66101A-08

S E R V I C E N O T E

66101A DC Power Supply

The instrument will not communicate or will not complete self test.

Diagram A: ROM not fully inserted

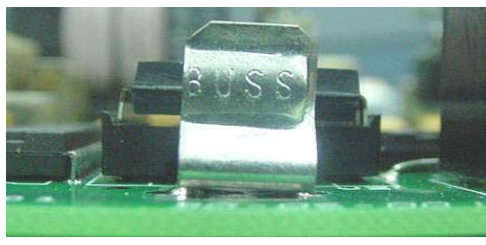
The Programmed ROM P/N 5080-2529 (Circuit Reference “U2”) See [Figure 1](#).below for the location of “U2”. When the ROM “U2” is not inserted correctly See [Diagram “A”](#) for details, the instrument may exhibit the following faults:

These faults could also occur if the ROM or the socket is intermittent due to dirty or contaminated pins.

1. The instrument will not turn on
2. All of the segments on the Front Panel display are not light.
3. The instrument will fail self test or will not boot-up.
4. The instrument will not communicate & can not be calibrated.

The ROM “U2” should be removed from the socket. (See [Figure 1](#)). The socket and the ROM should be inspected for contamination or other defects. The ROM is a ceramic part and can be damaged or broken if too much force is applied when reinstalled. [Diagram “B”](#) shows the ROM “U2” inserted correctly.
